**TOWN OF PLYMOUTH
PLYMOUTH MUNICIPAL AIRPORT**

CONSTRUCT, MARK, AND LIGHT TAXIWAY 'E' EXTENSION (APPROX. 500' X 35')

ADDENDUM No. 3

Date: December 22, 2020

D1.1

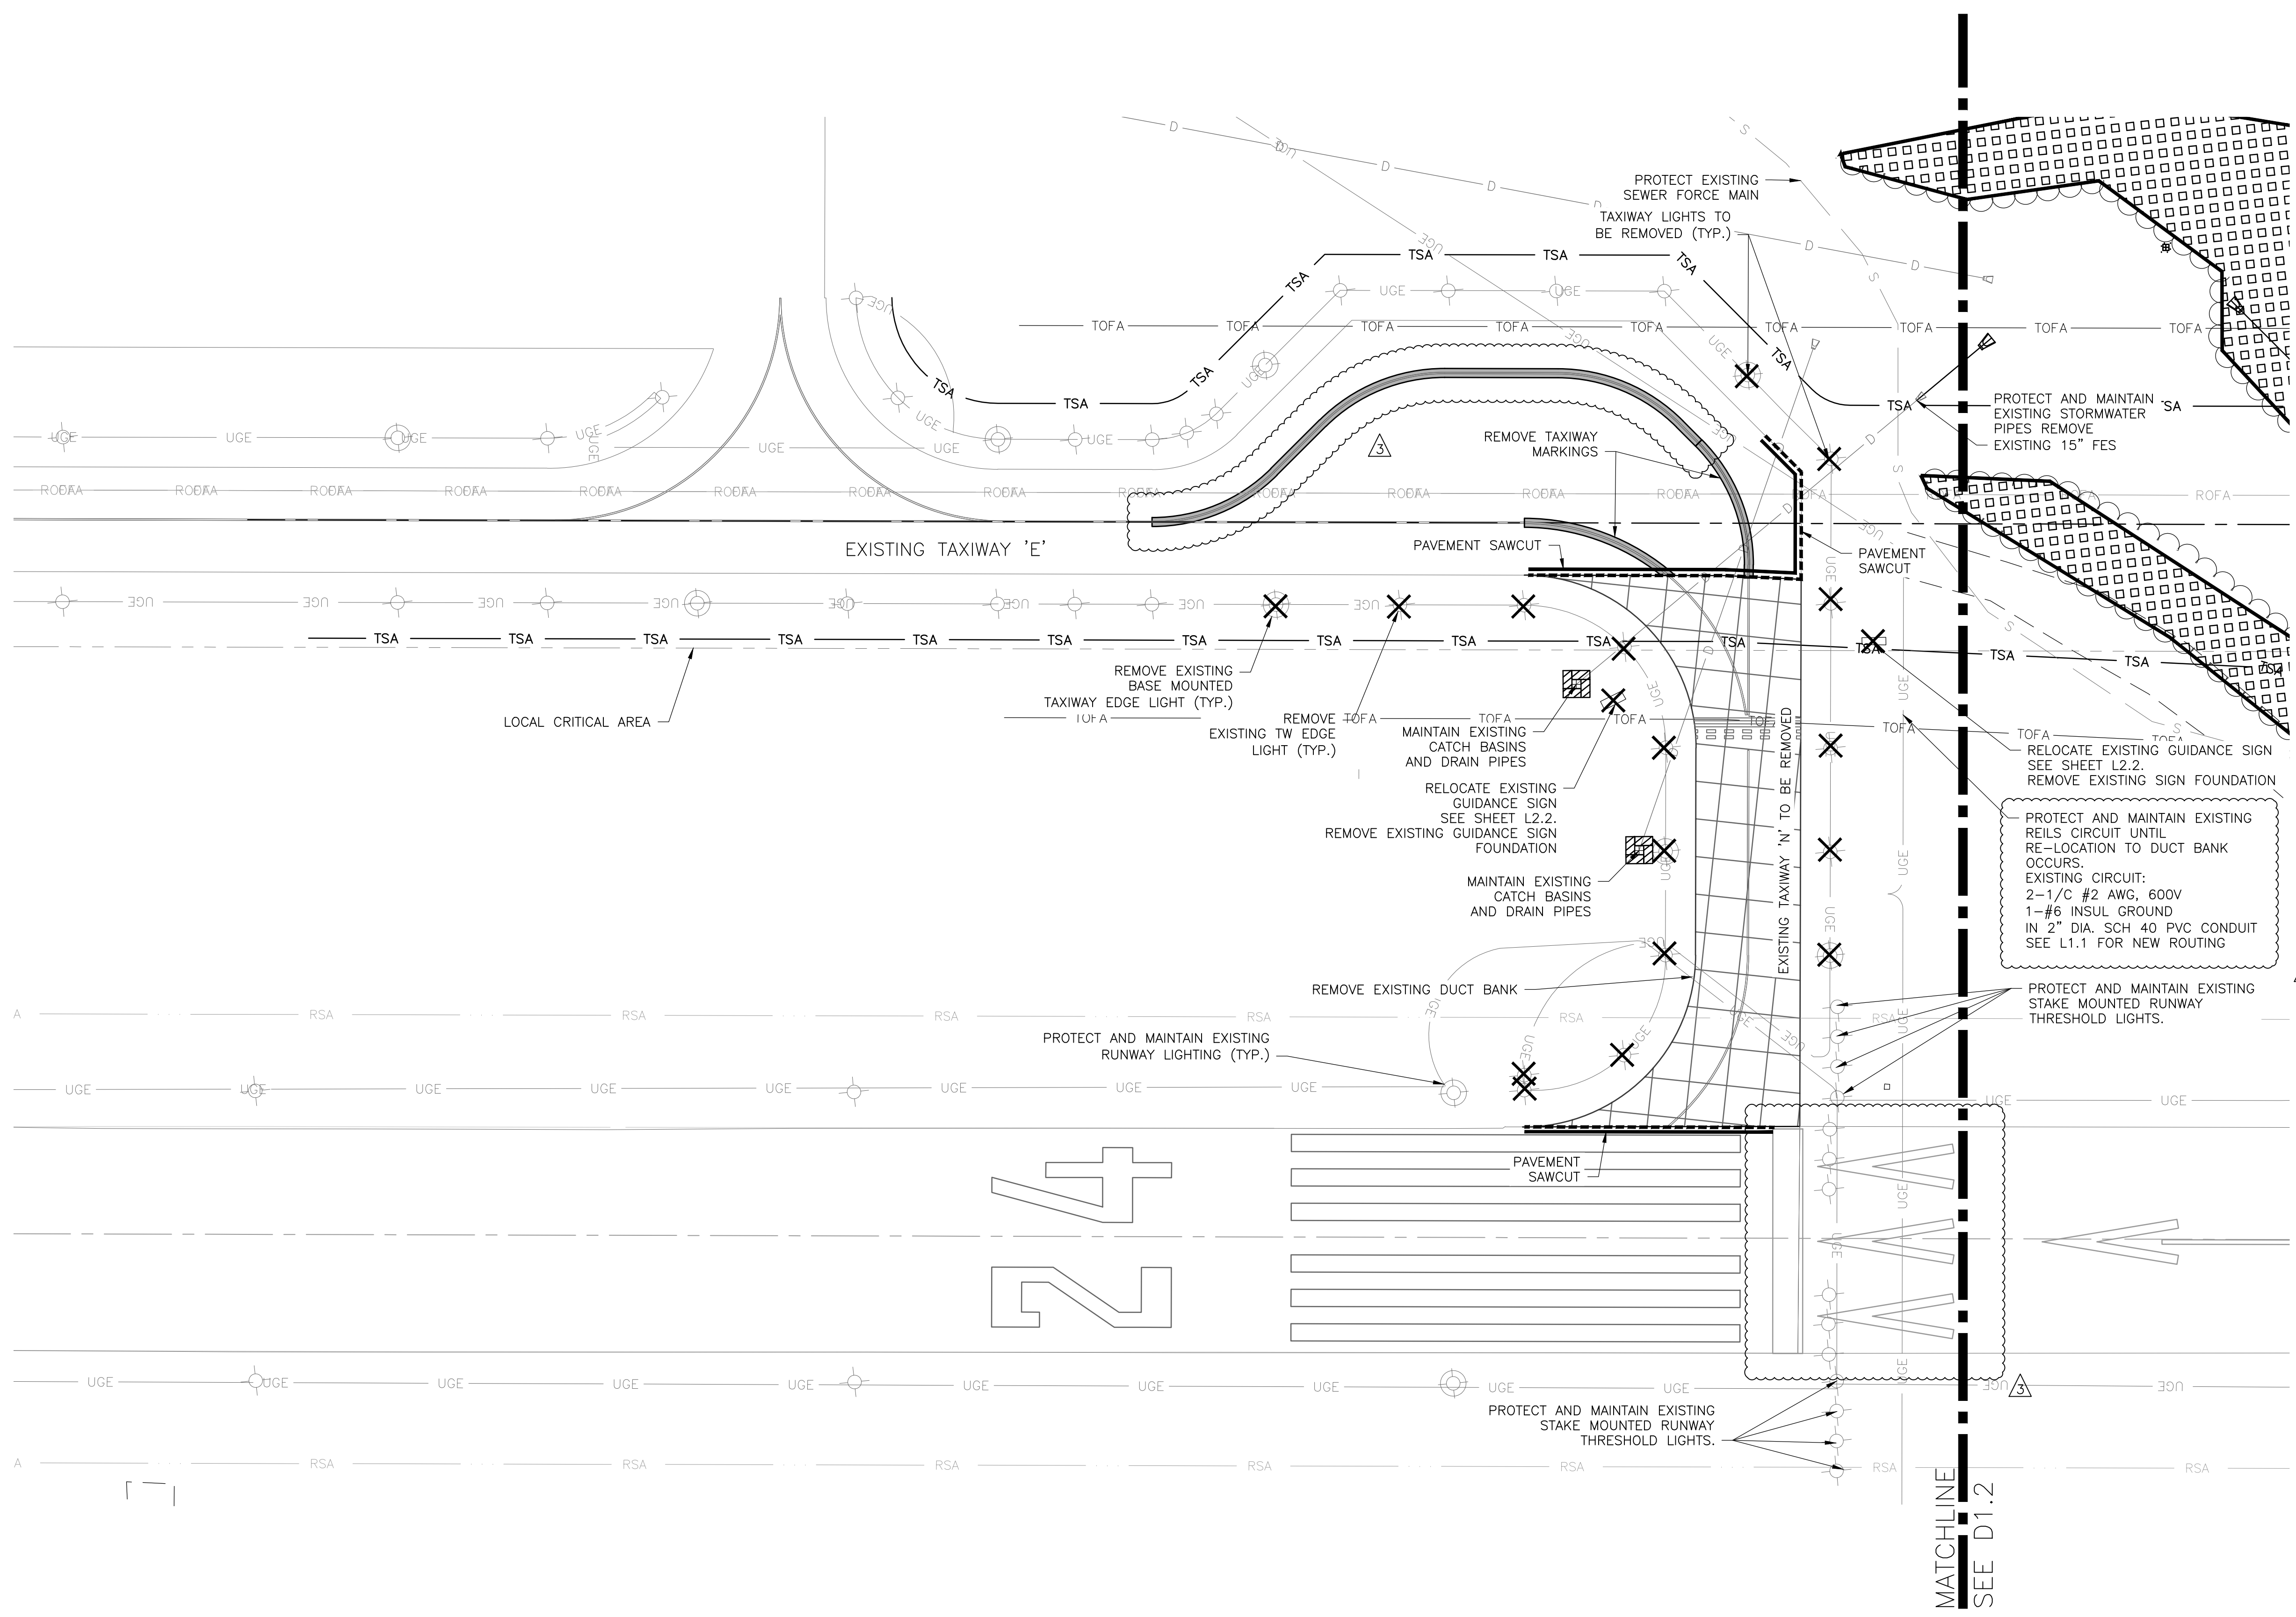
8. Drawing D1.1 has been revised to remove the previous proposed RW 6-24 trench and removal of in-ground threshold lights. Additionally, the limits of pavement marking removal has been extended on the TW E runup apron.

C1.2

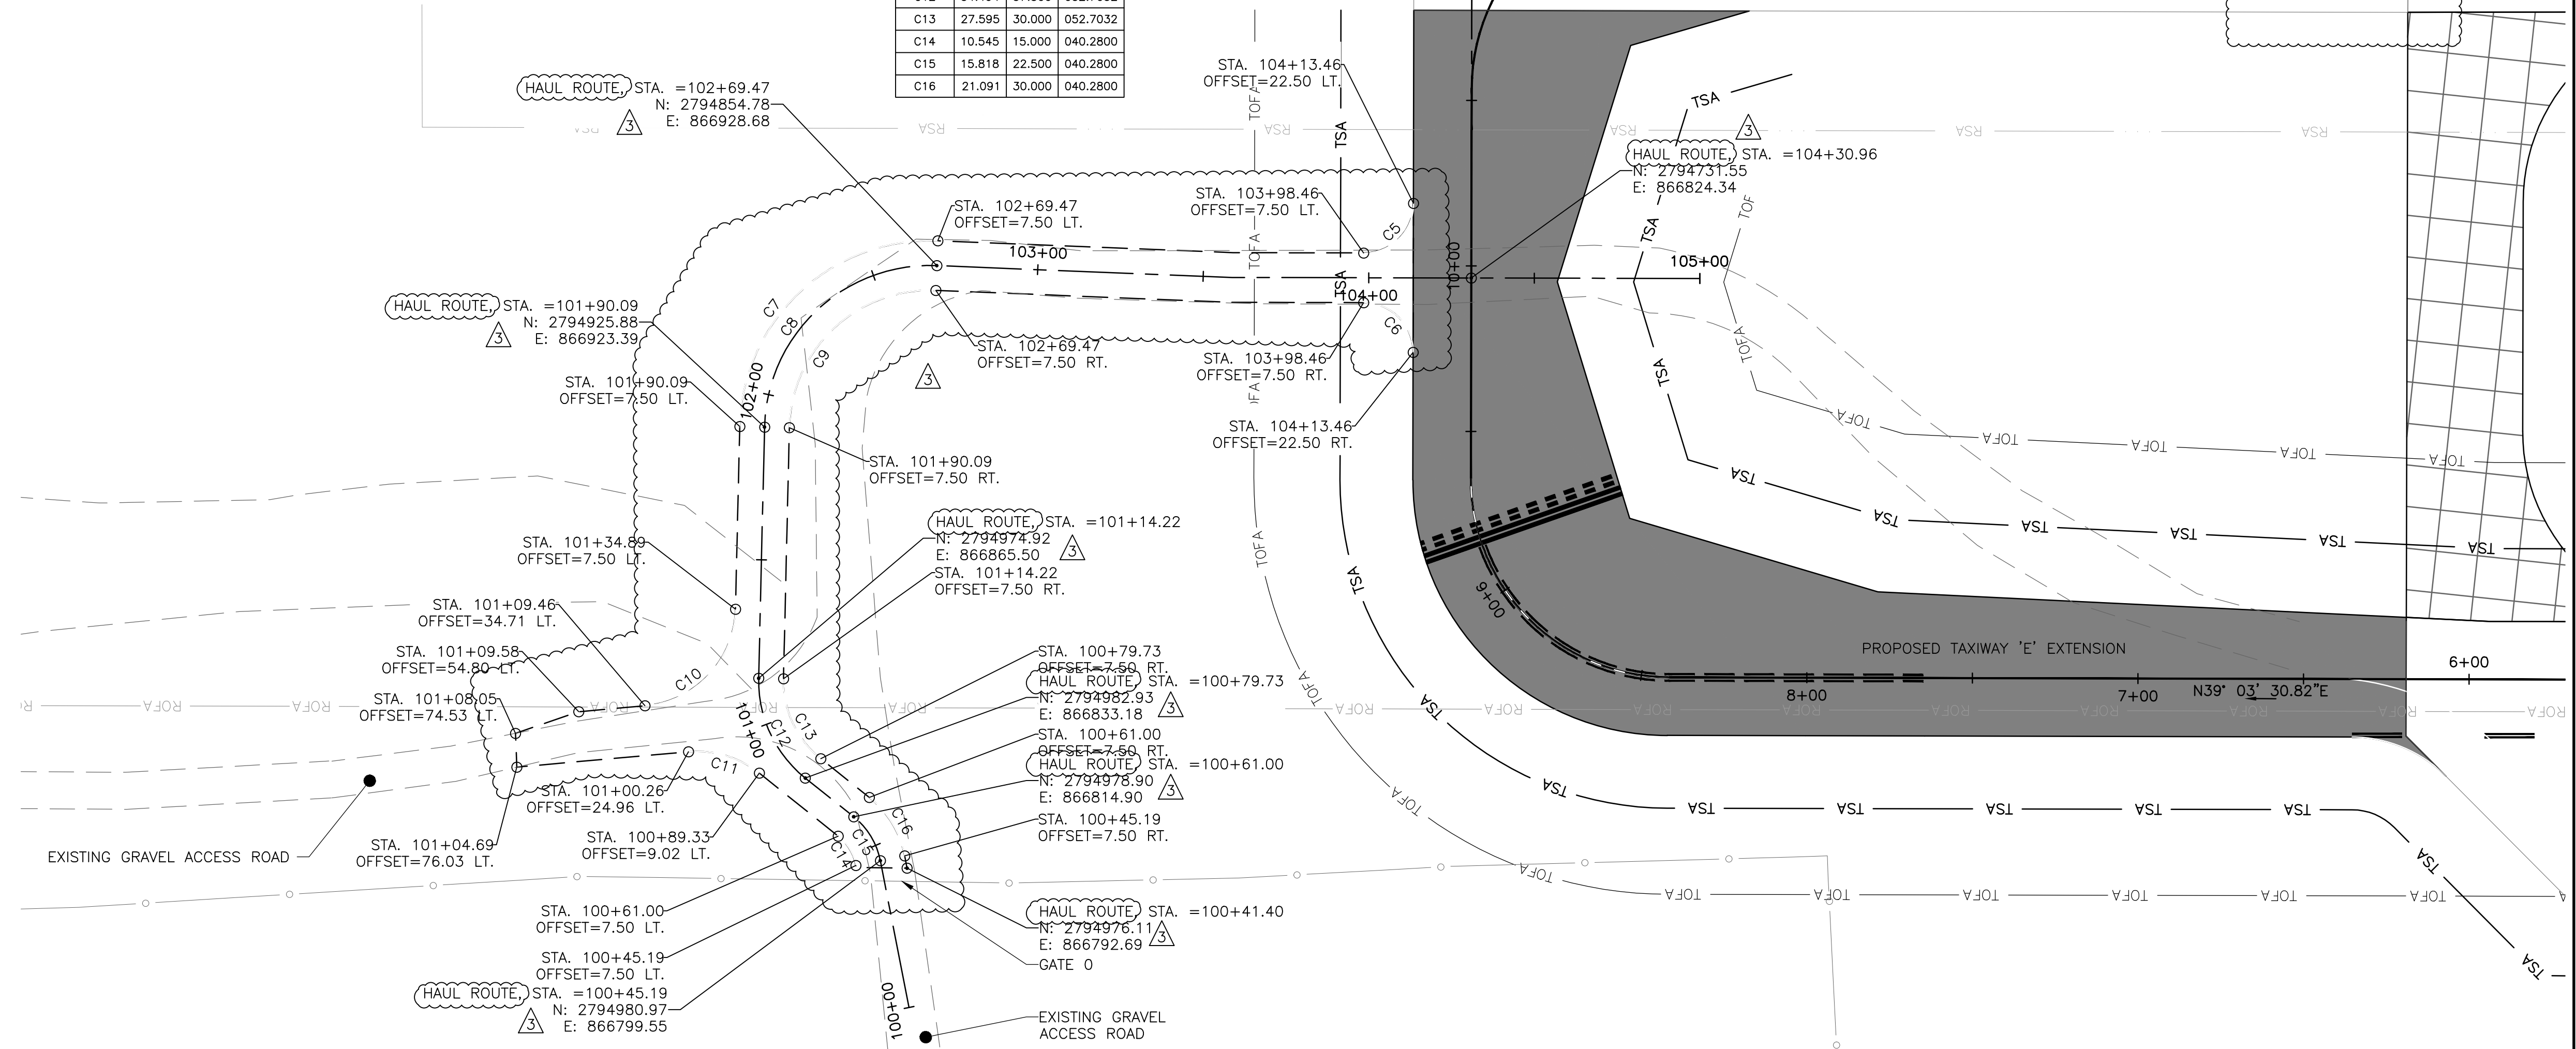
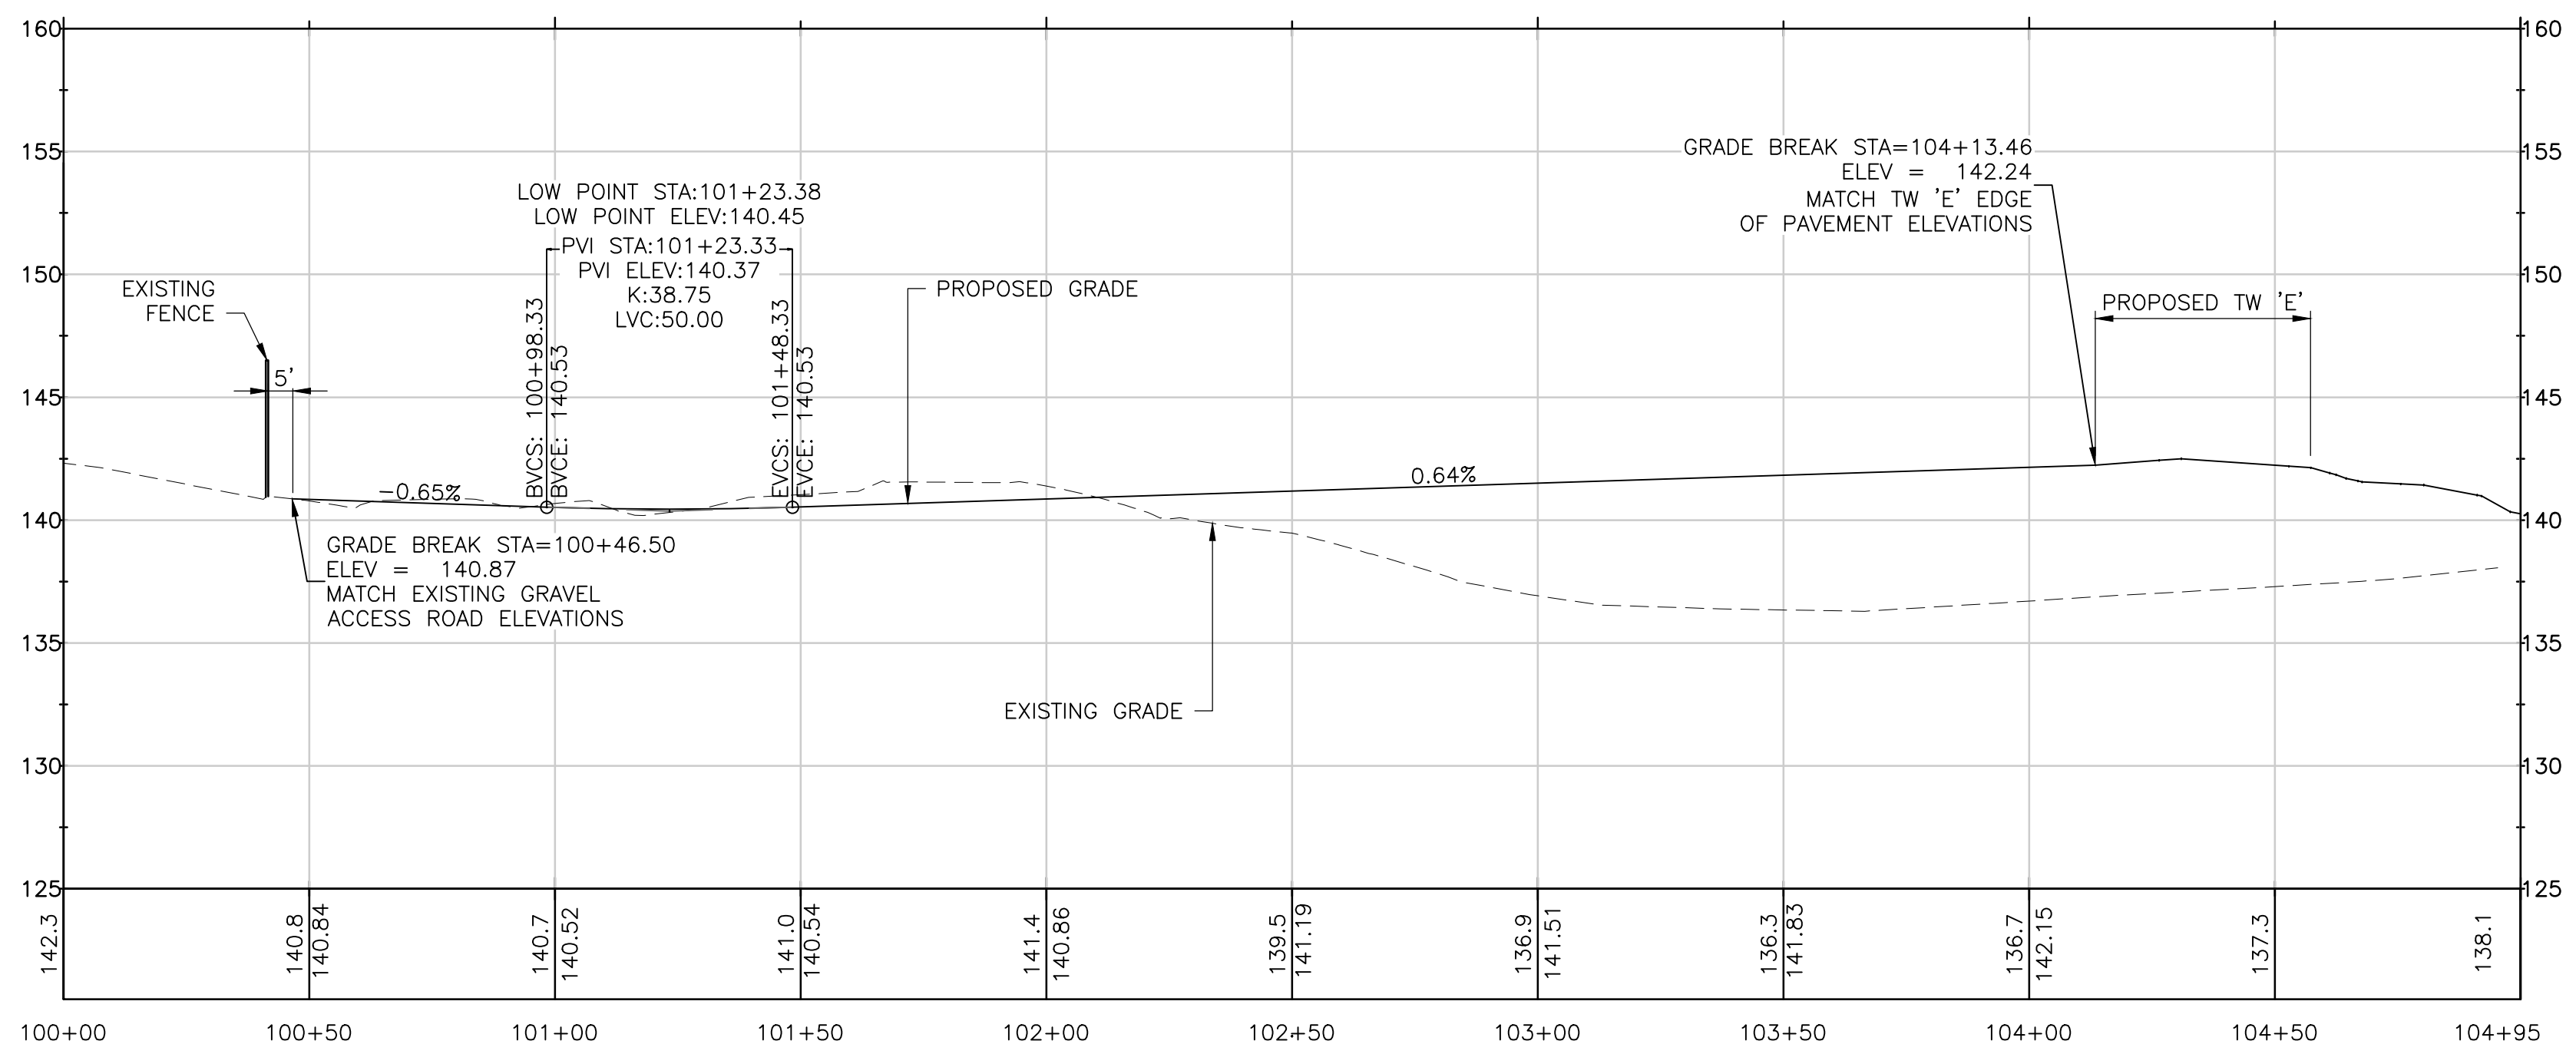
9. Drawing C1.2 has been revised to clarify that the proposed haul route is not to be paved.
10. Drawing C2.1 has been revised to clarify the Typical Section that the embankment fill is P-152. Additionally, the RW trench detail has been removed. The Haul Route Typical section has been revised to show the final treatment of topsoil, mulch, seed. The Typical Taper section has been revised to show the intended use at RW edge for temporarily transition the pavement edge to eliminate a drop of more than 1.5 inches.
